PROPOSAL REQUEST FOR INFORMATION (RFI) FORM

SOLICITATION: VA261-16-B-0516- Bldg. 700 4th Floor Renovation

Project Number
612-101C
Building Number
700
Drawing No.
E1.31
Dwg. of

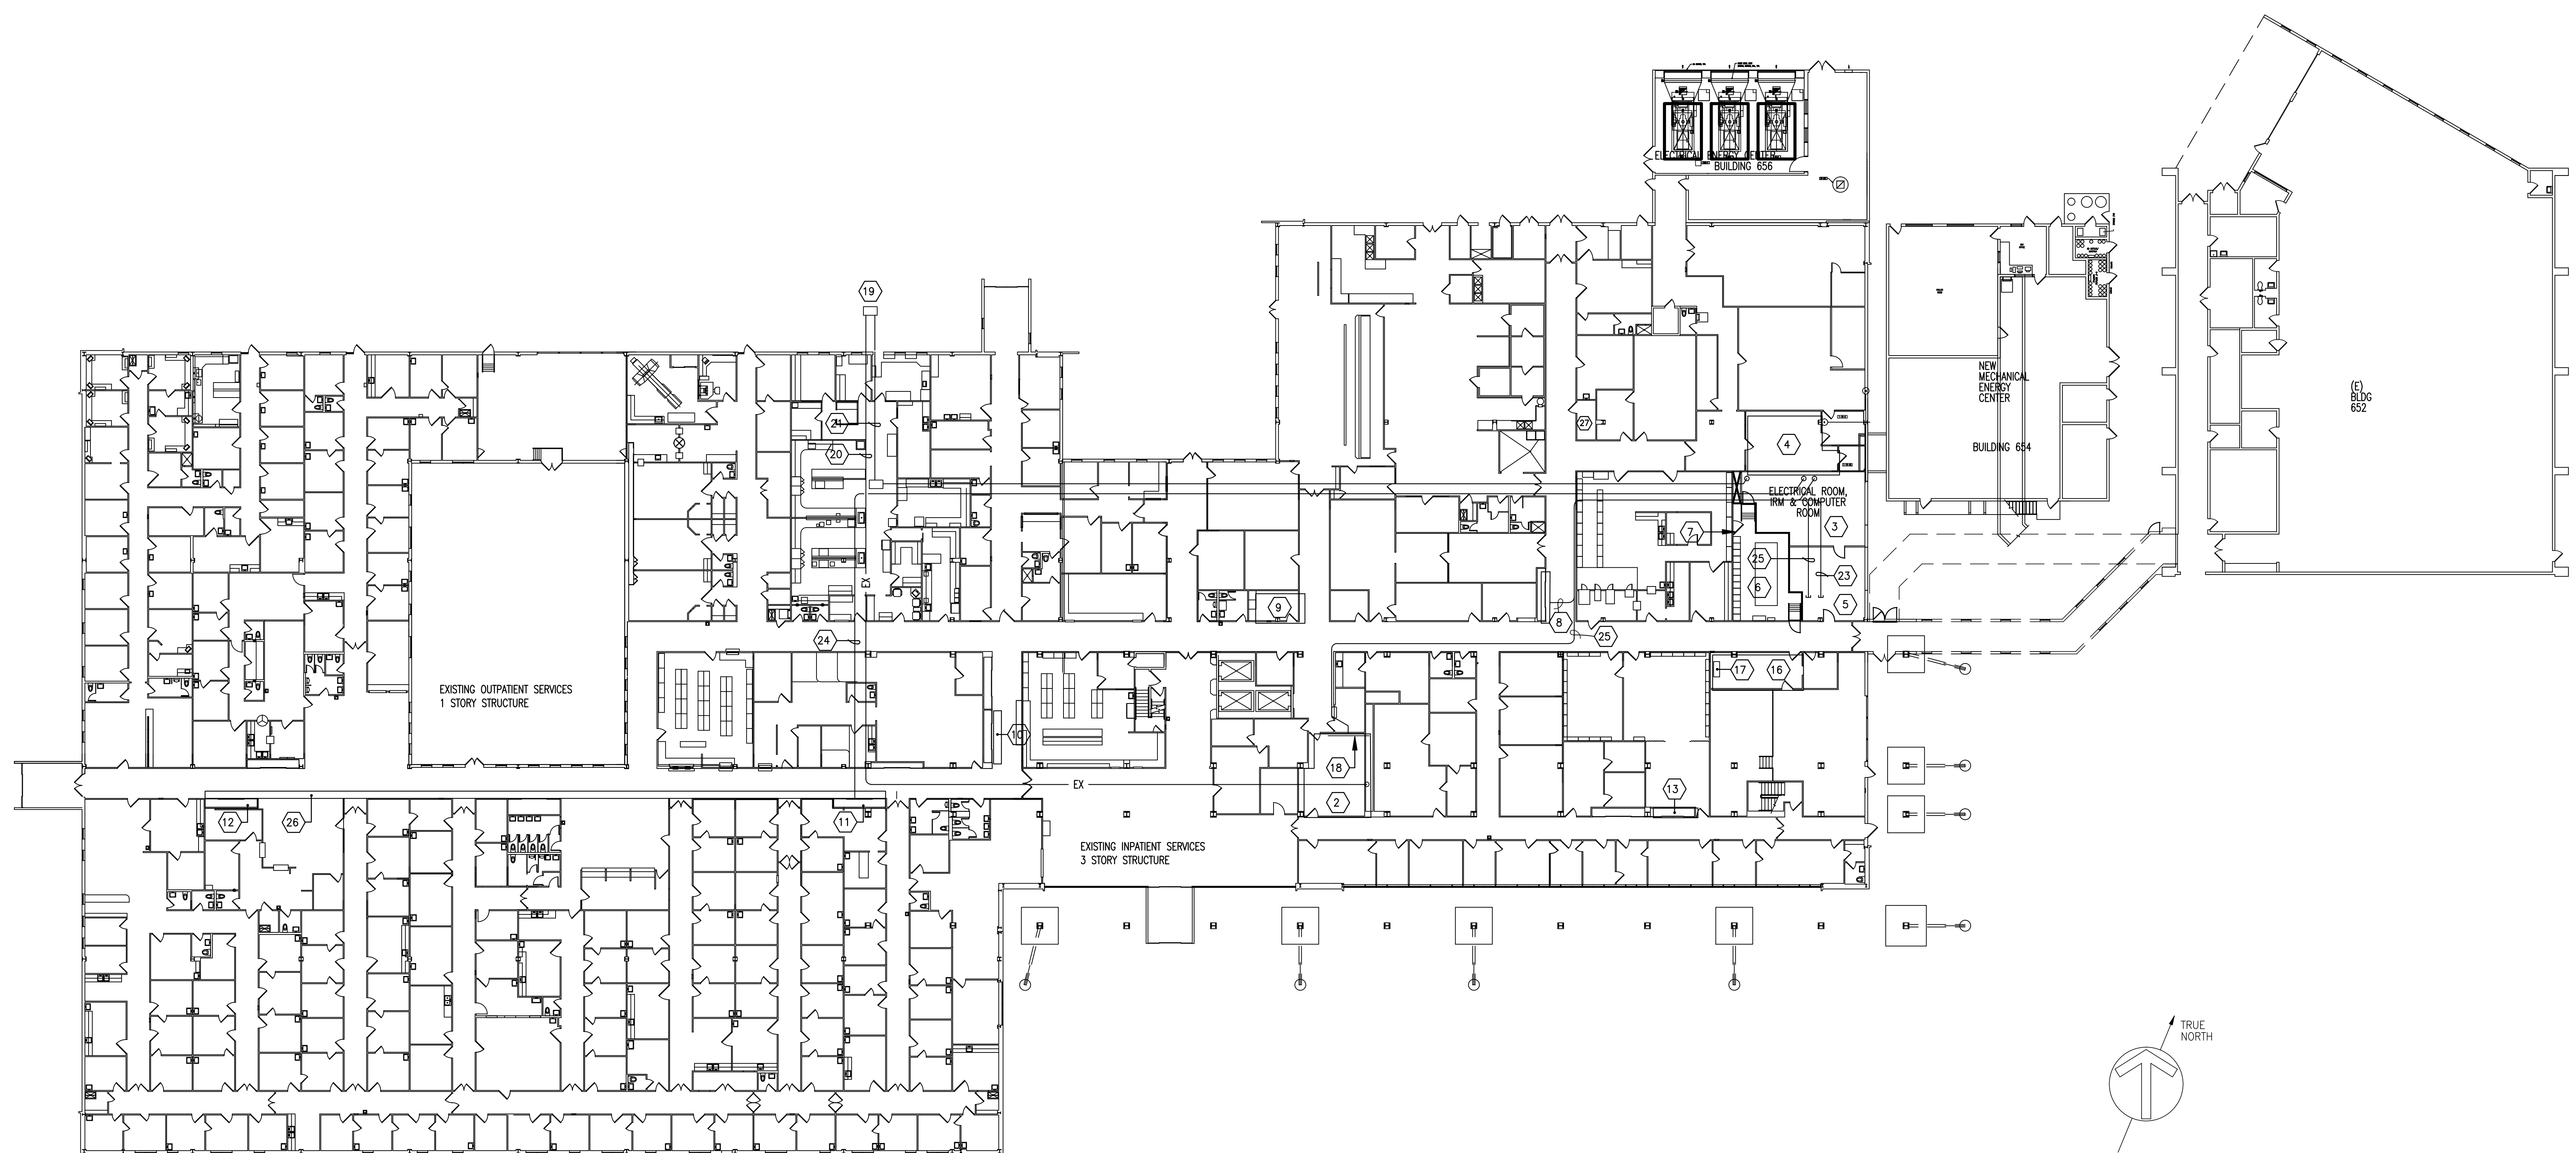
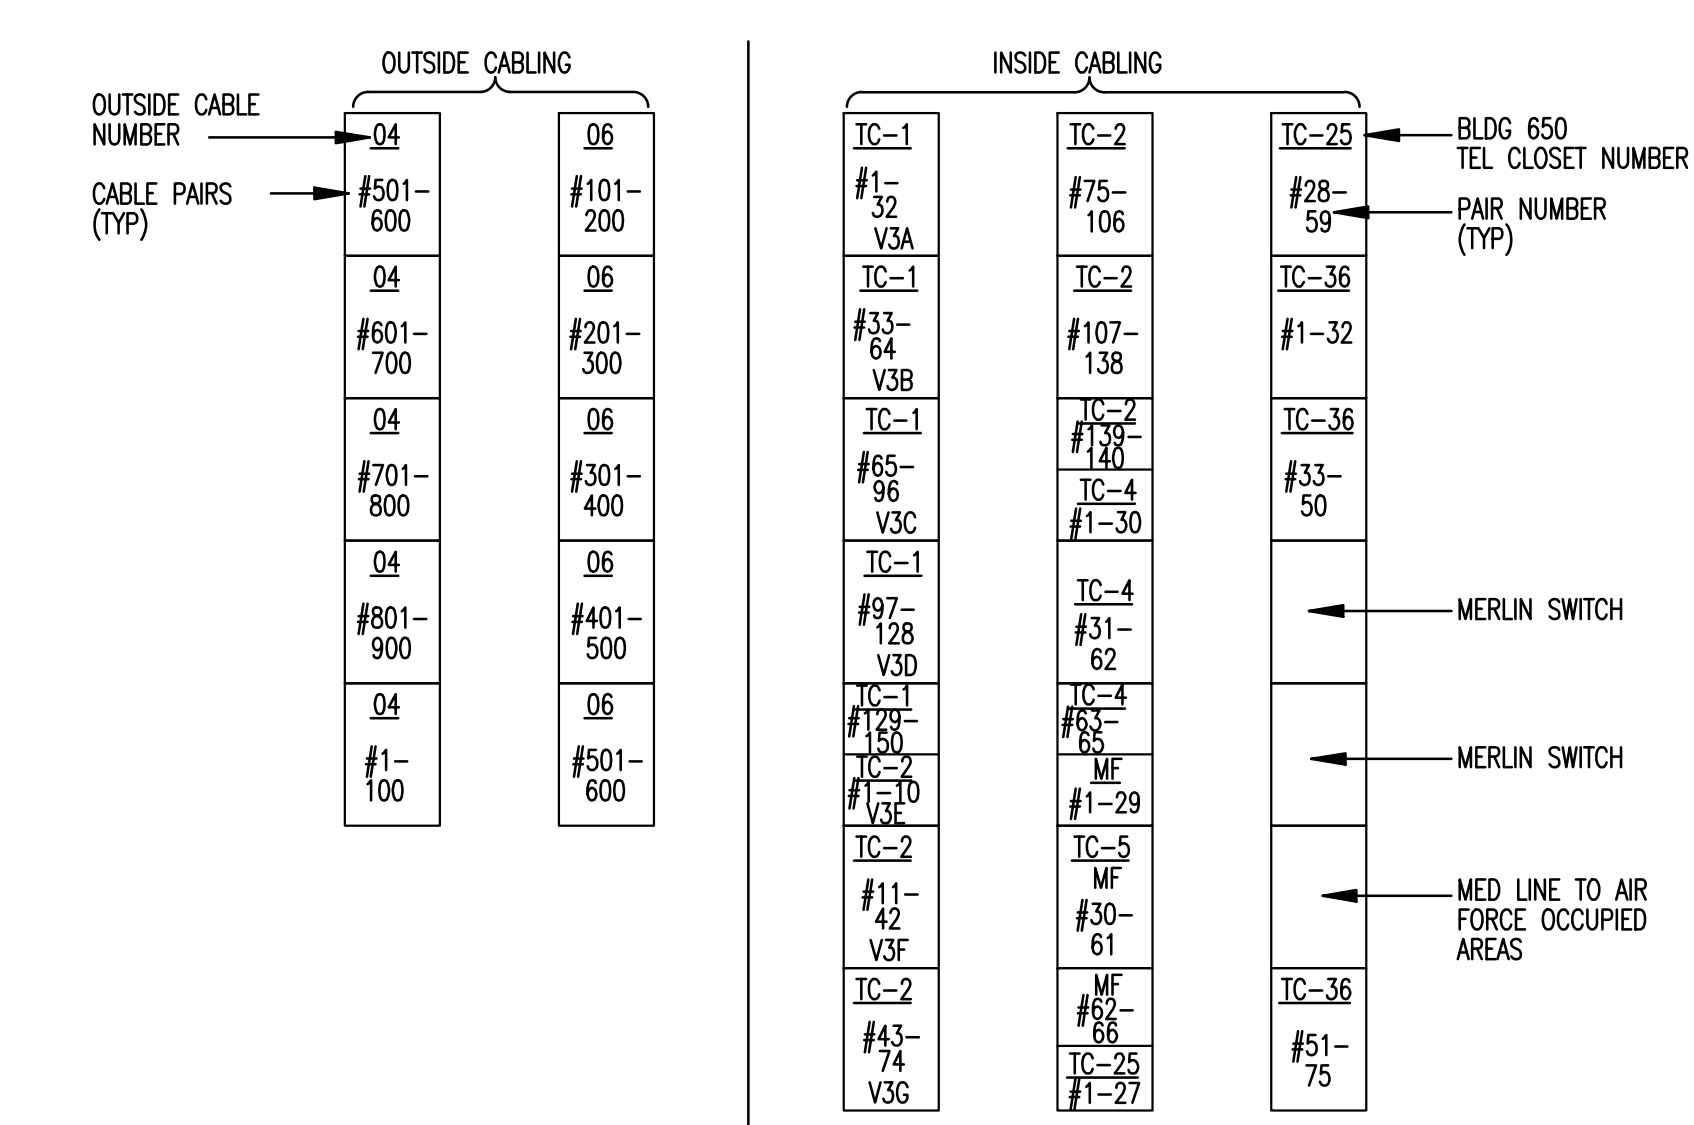
Proposal RFI #1 - Do you have any drawings showing the back bone cabling?

RFI #1 - Record drawings available to the design team have been attached (Sheets E1.30 and E1.31 dated December 15, 2000). Additional record drawings showing additional details for the back bone cabling may be available from the VA.
